BRIOHN DESIGN GROUP, LLC
A DIVISION OF BRIOHN BUILDING CORPORATION

September 15th, 2026

RE: N69 W20947 Pleasant St, Menomonee Falls, WI. Structural Inspection

Photo #1 – 5 course garage wall retaining soil

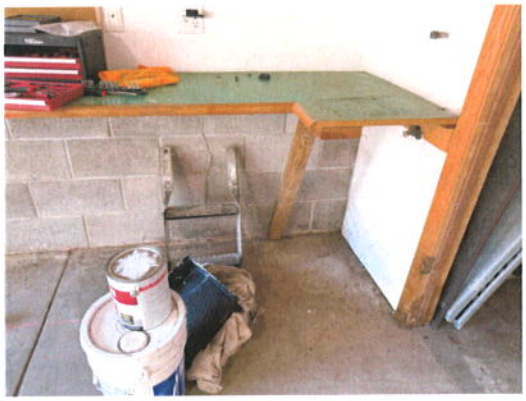
However, the photos below indicate movement of the longer NE wall. The wall is visually bowed lengthwise and in the 5 courses of height, the wall is tipped inward up to ½" with up to 7/8" of base shear. In my opinion, the wall should be reinforced with #5 re-bar and grouted at 4'-0" o.c.. To accomplish this, the 2X top plate should be cut to access the hollow core at 4'-0" o.c. These openings will allow access to install the re-bar and grout. Water control and grading along this wall should be done to avoid a build-up of water/soil pressure.

Photo #4 – NE basement garage wall – brace per WAFRP standards.

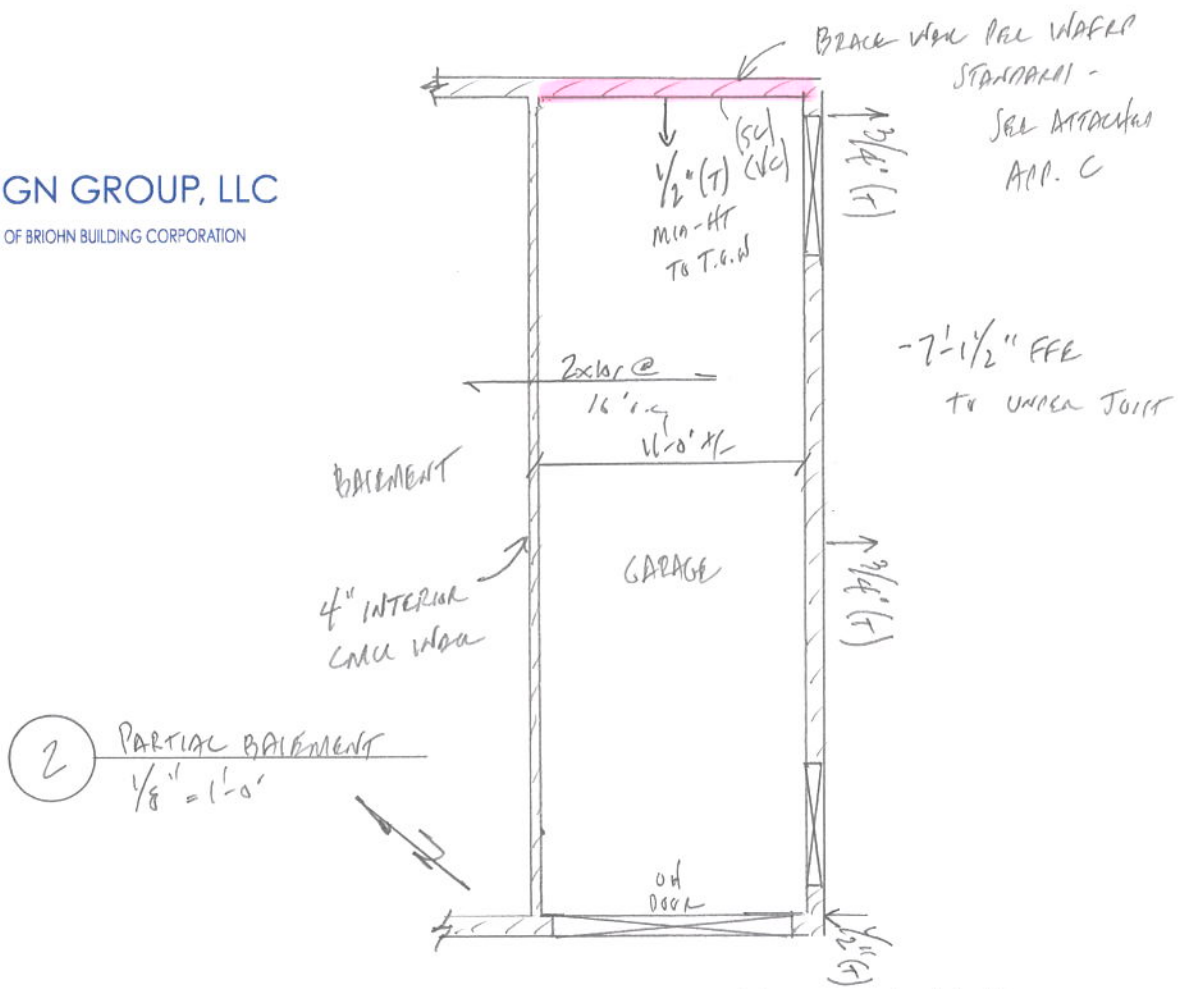
The attached garage SE wall was measured to be tipped outward up to ¾". No active cracking was noted at the time of the inspection and since the wall is tipped outward, steel bracing is not required. The NE wall of the attached garage had wood stacked against the wall but was measured to be tipped inward up to ½" from the mid-height of the wall to the top. Horizontal, step and vertical cracking was present on the wall indicating active lateral movement. In my opinion, this wall should be braced per WAFRP standards. No excavation is required. Grading should be assessed and monitored seasonally to assure proper drainage away from the walls.

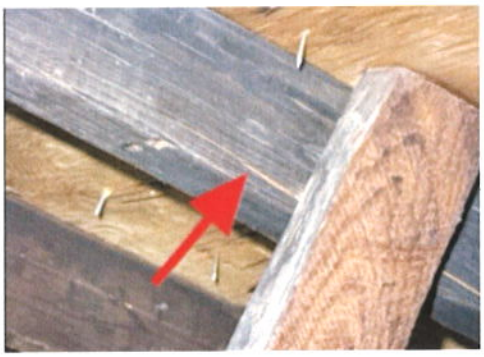
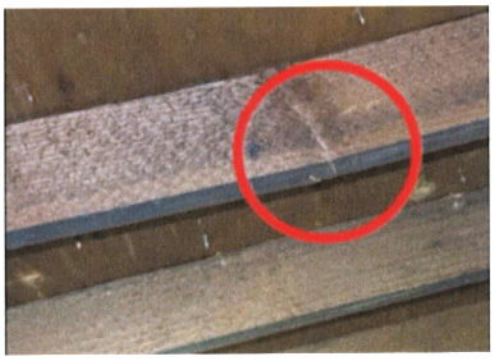
Photos from home inspection report show 2x10 floor joists that were cut for ductwork. These floor joists have been compromised and should be reinforced with an additional 2x10 nailed into the existing 2x10.
